CDW CONSULTANTS, INC.
CIVIL & ENVIRONMENTAL ENGINEERS

November 16, 2016

Re: Permit No. MA0003590: Request to Change Discharge Monitoring Location and Flowrate Monitoring
MBTA Commuter Rail Maintenance Facility: 70 Rear 3rd Avenue, Somerville, MA 02143

| SHEET: 000-C-2063 | |

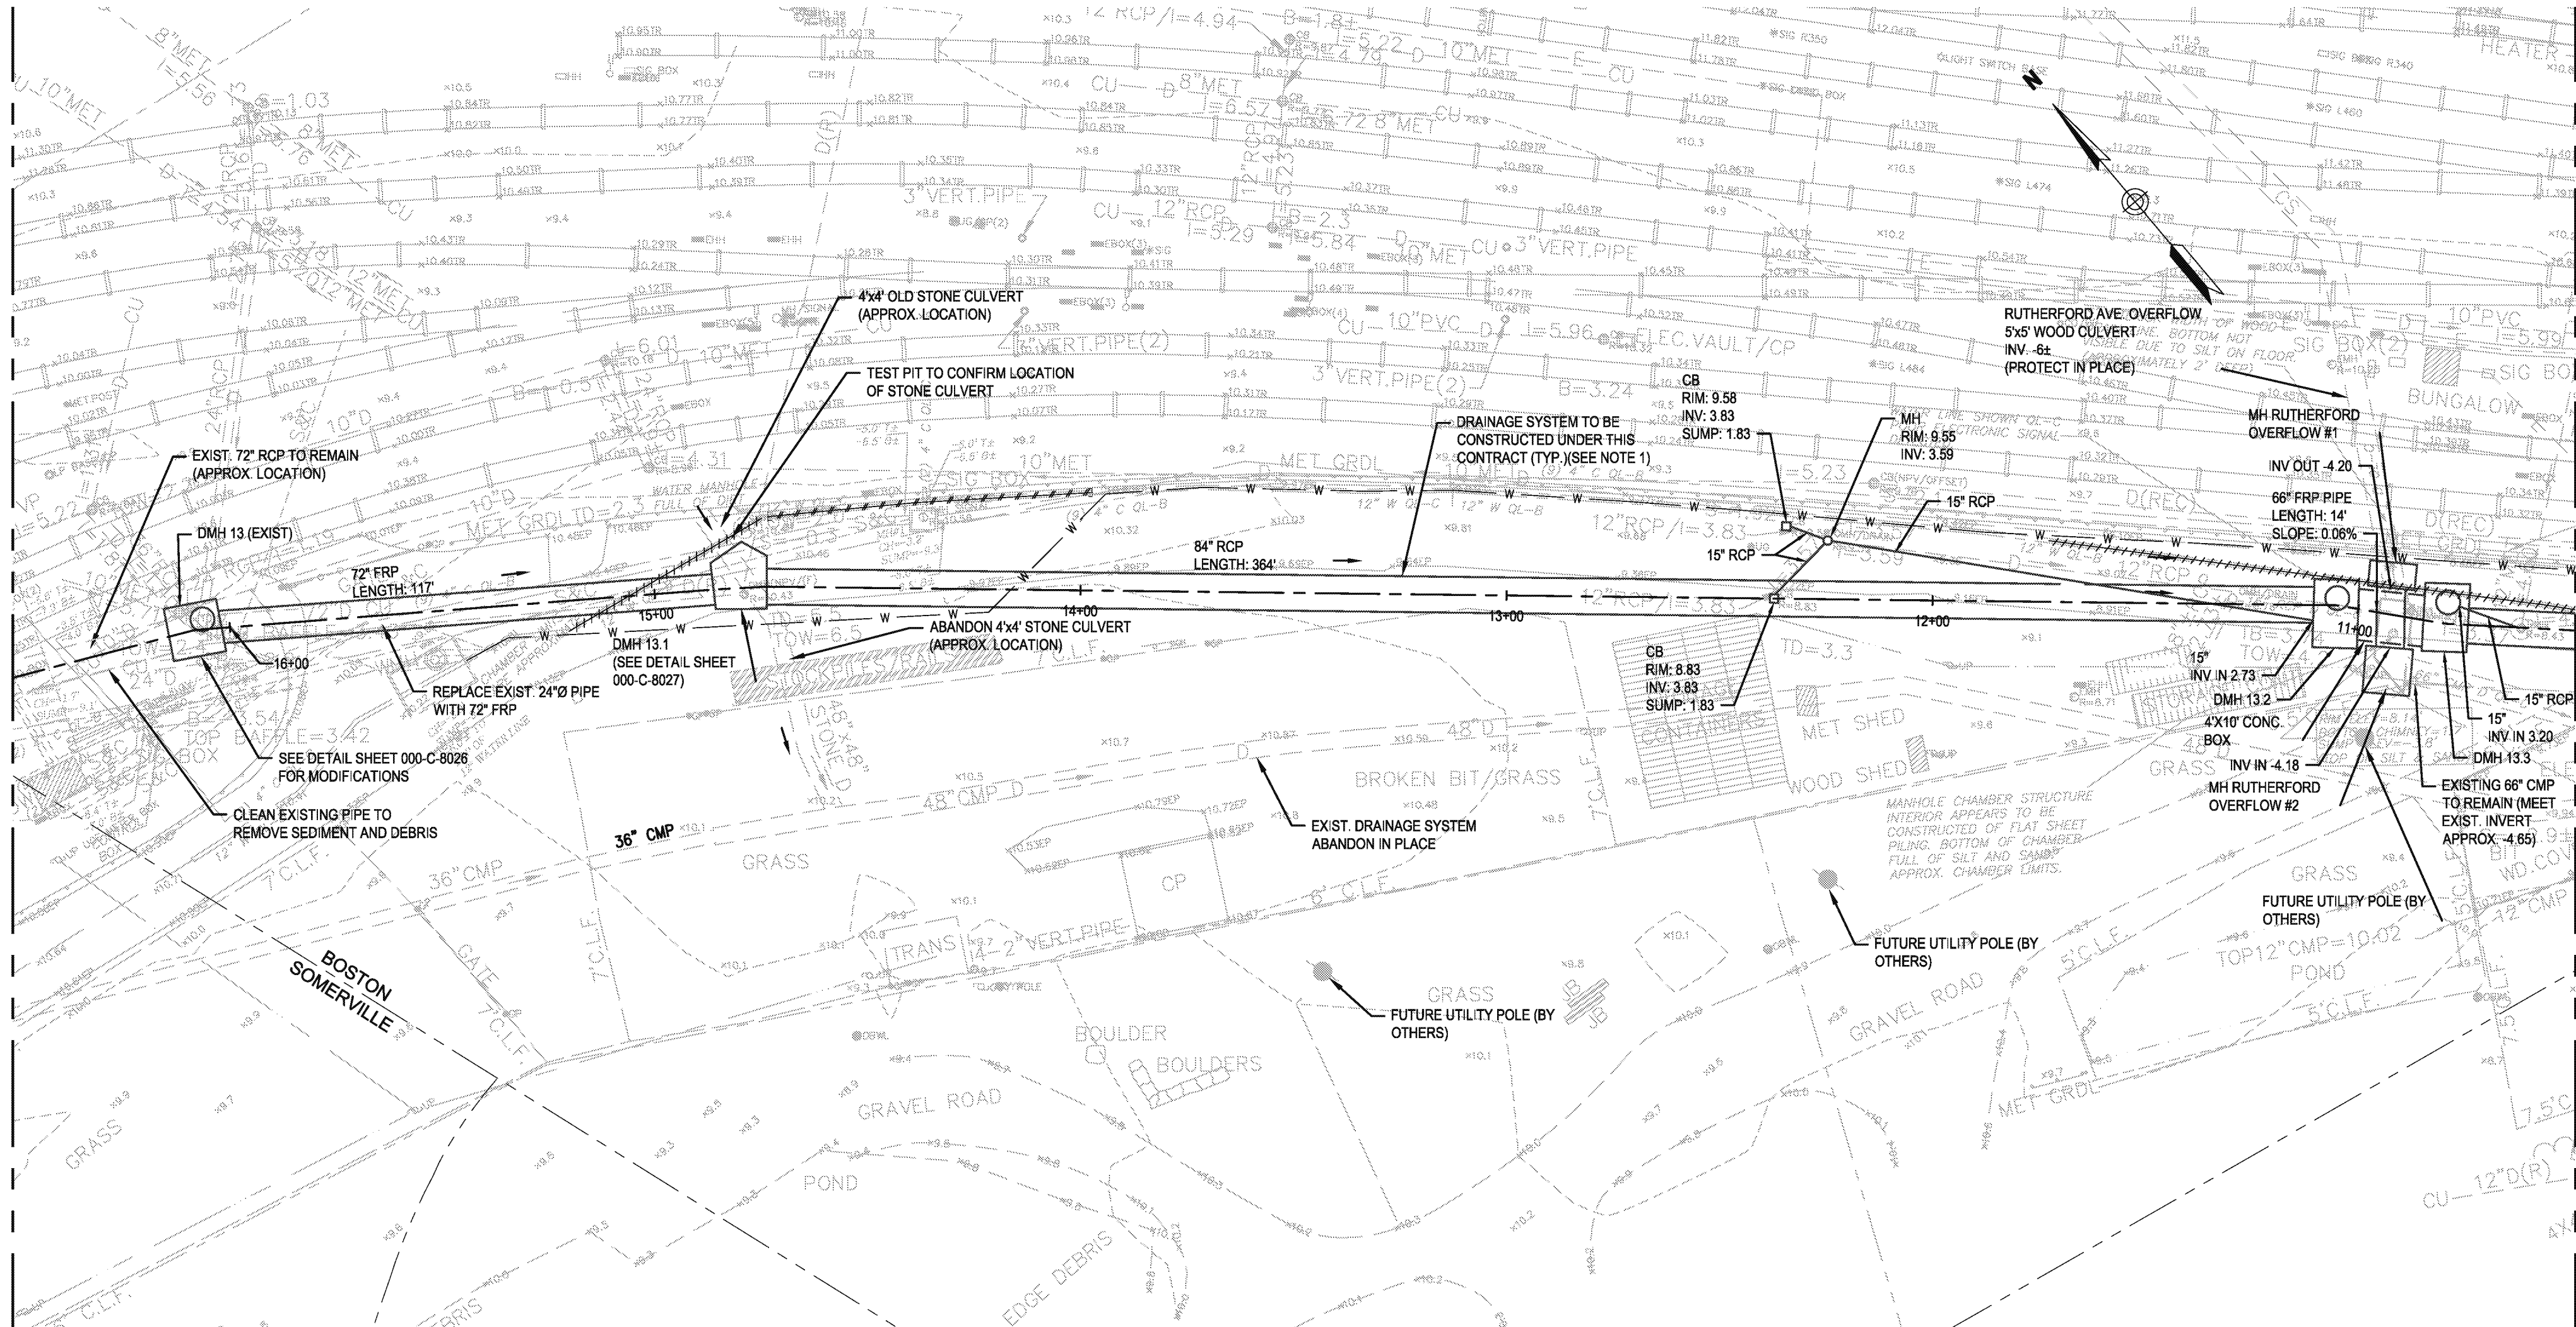
With the exception of *de minimis* quantity of stormwater from the Gilmore Bridge and the North Point area, the new drainage system no longer directs flow through Prison Point. A new 84" drain pipe directs the flow to a new drainage chamber access point, designated as **DMH 13.4** (see attached sheets 000-C-2061, 000-C-2062, and 000-C-2063). This access point is the *last available sampling location* before all flow from the drainage area discharges directly into the Millers River via three discharge pipes.

| DATE: SEP 12, 2014 | | LAN | BJS | ANC | SHEET: 000-C-8028 |

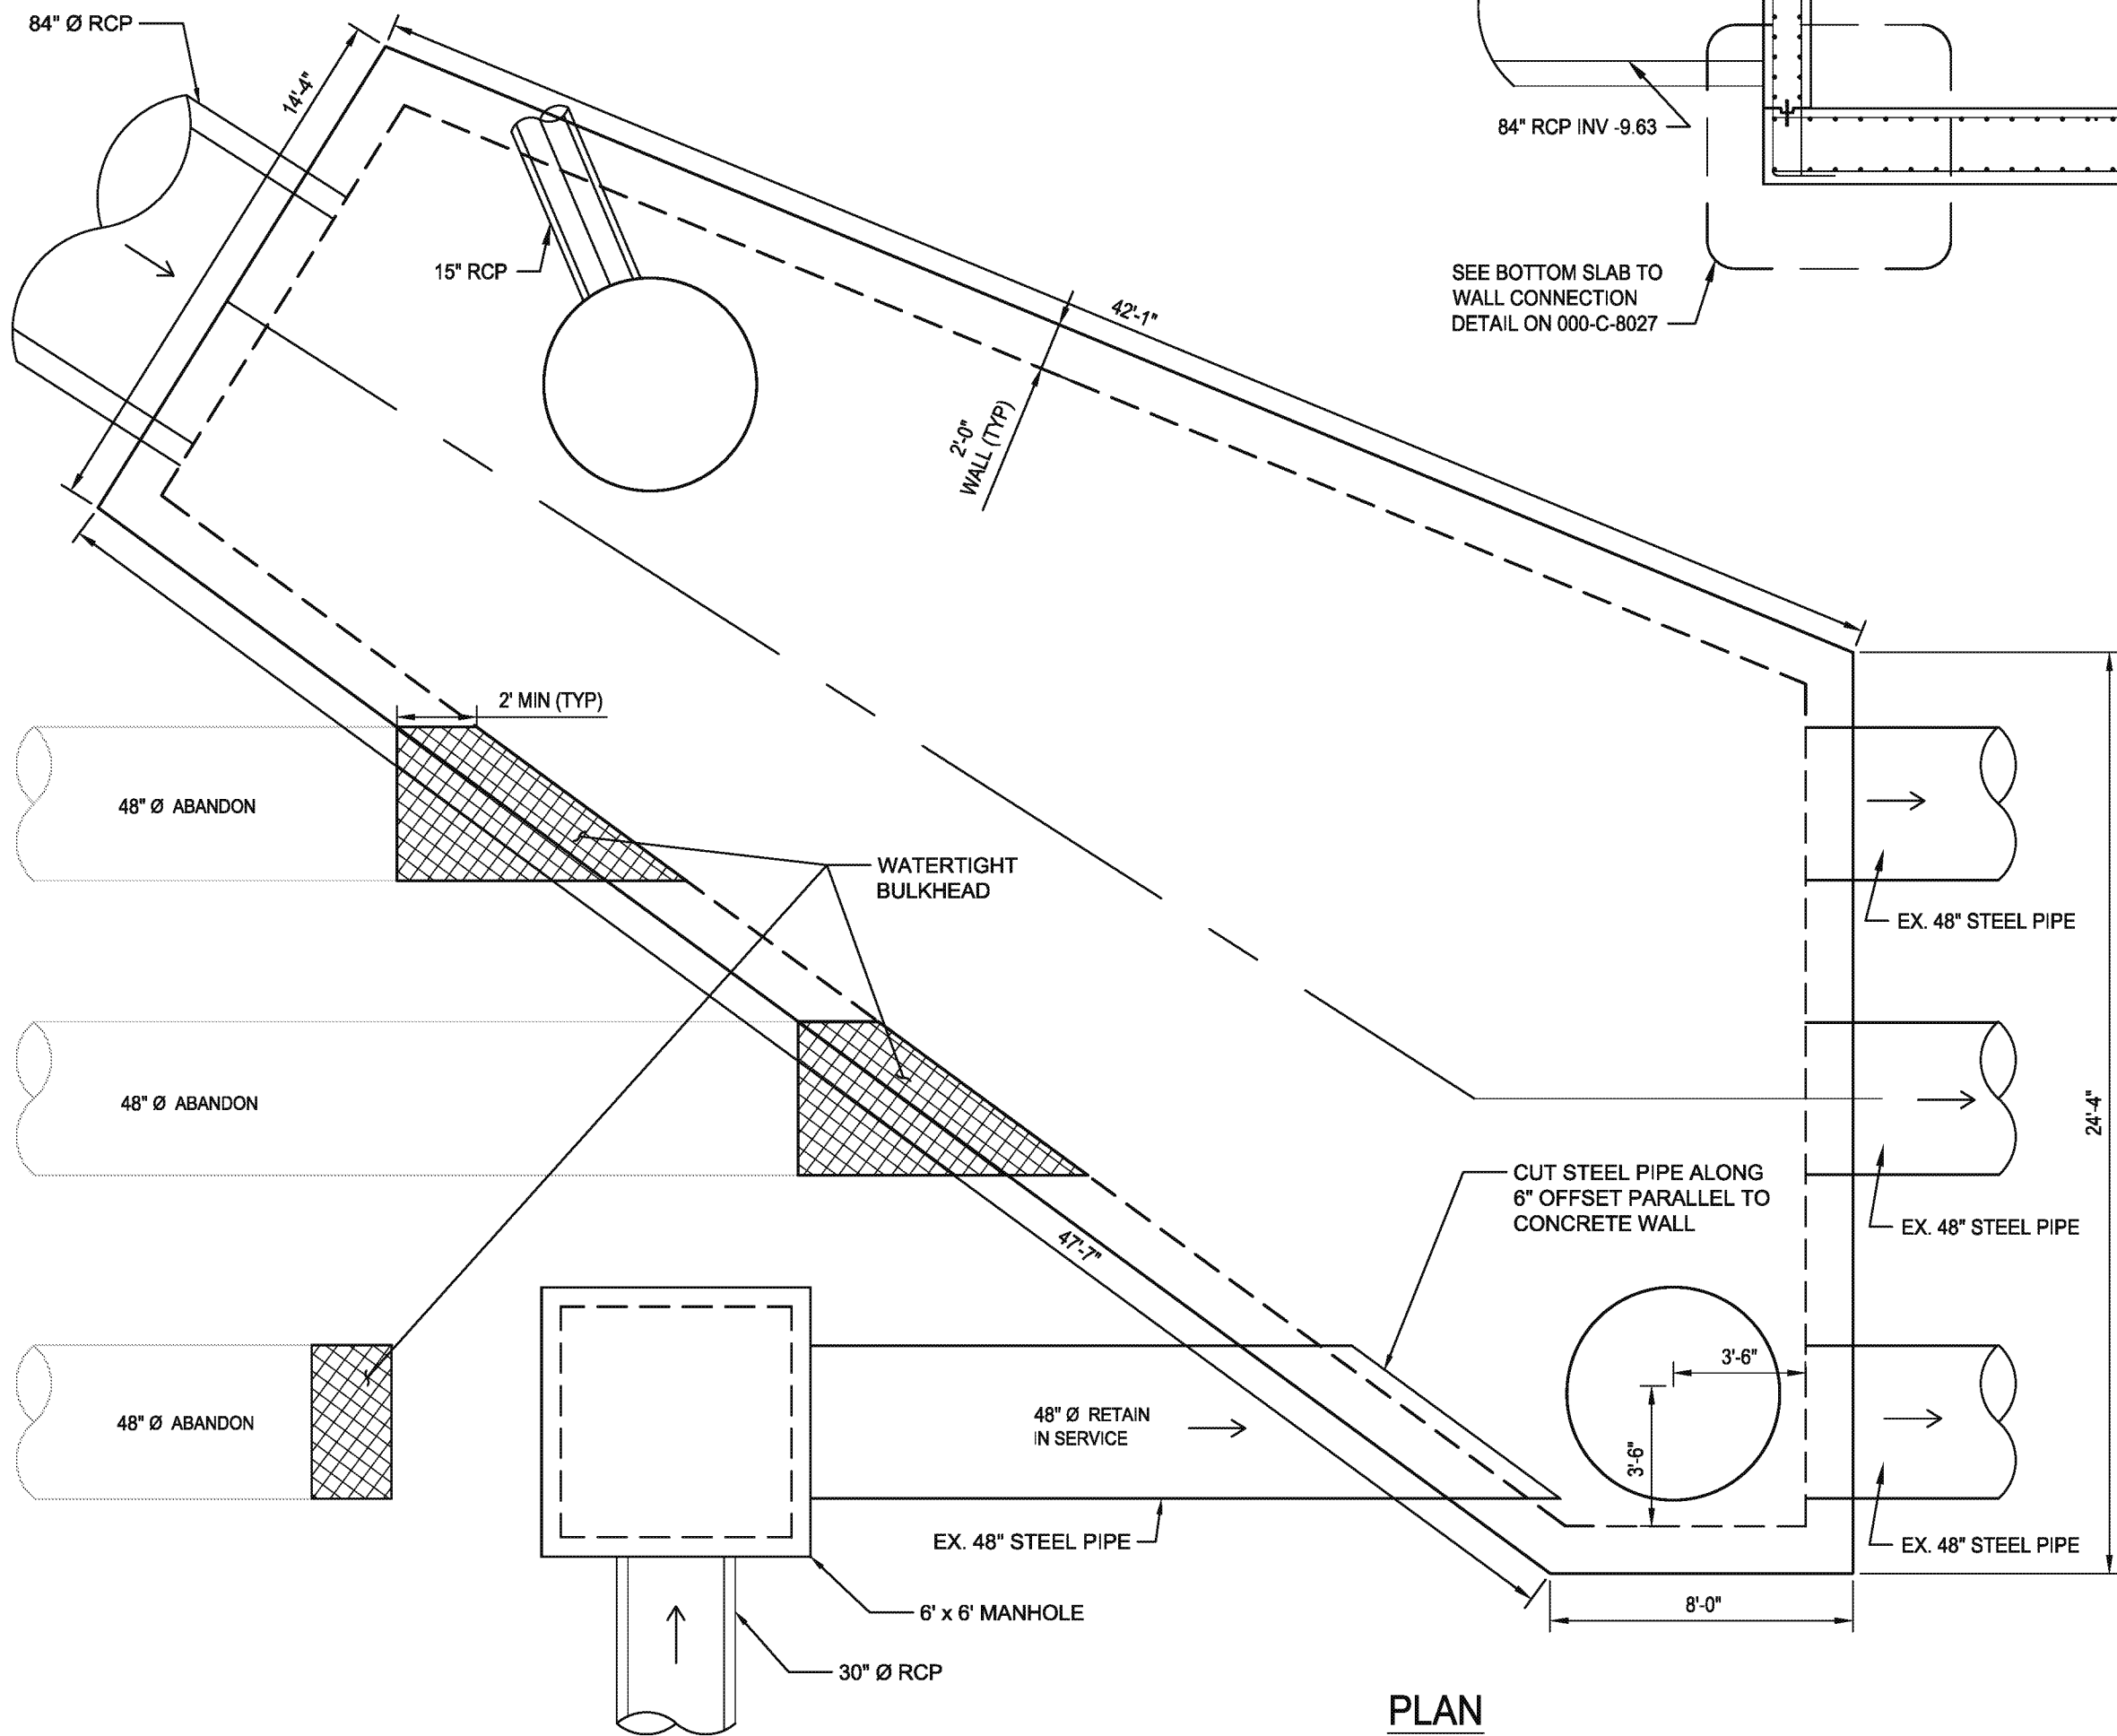
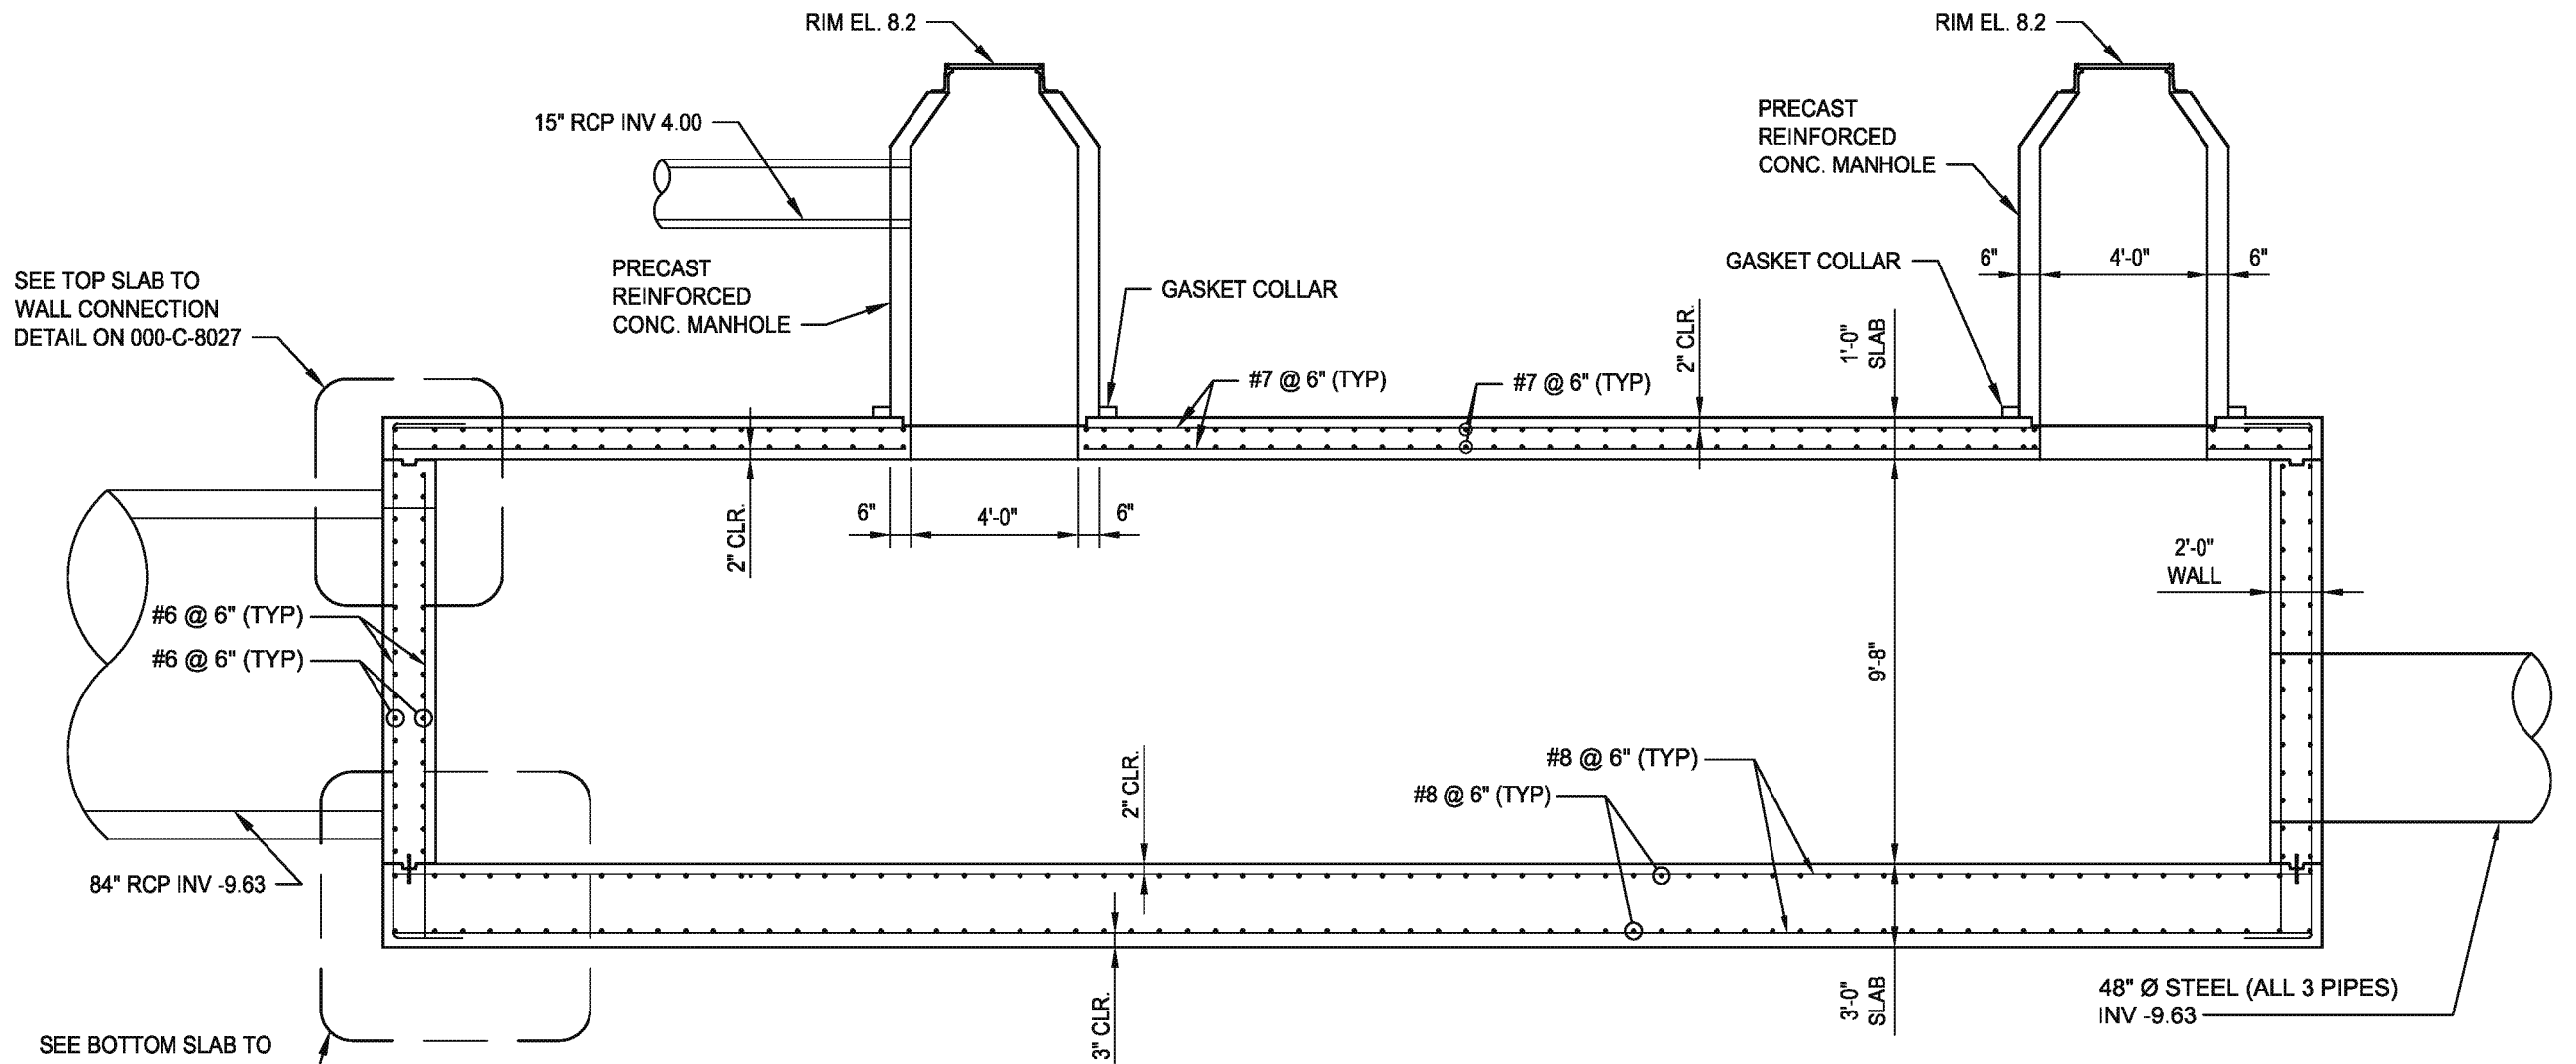
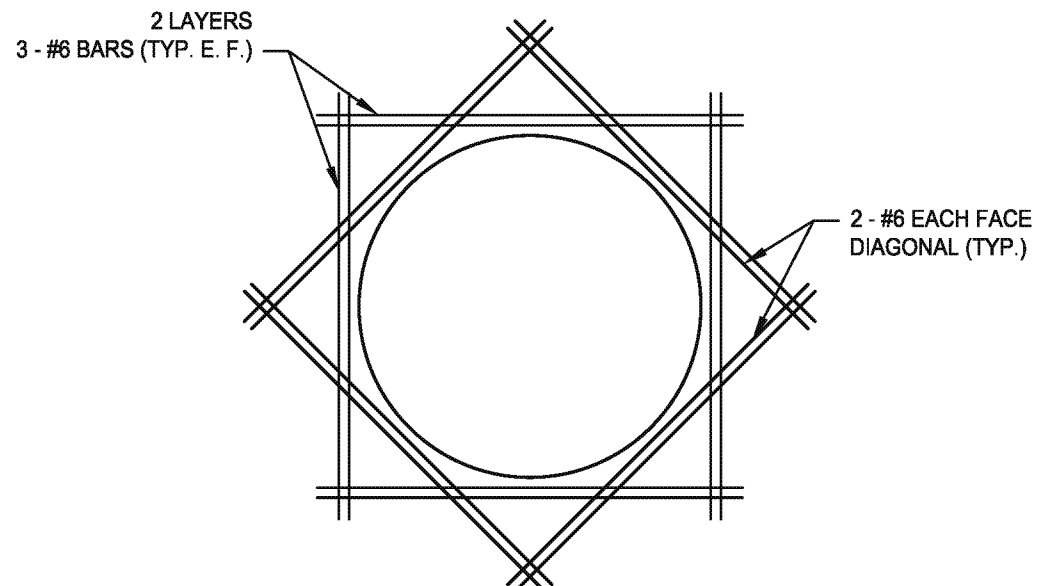
The MBTA and Keolis request to change the discharge monitoring location from the downstream end of the Prison Point OWS to the downstream end of the new **DMH 13.4** chamber, just prior to discharge into the outfall pipes. The DMH 13.4 chamber is surcharged above the outfall pipes under normal conditions. Therefore, sampling will be conducted at the approximate depth of the centerline of the outfall pipes, which corresponds to a depth of approximately 14 feet below the manhole rim (see attached sheet 000-C-8028).
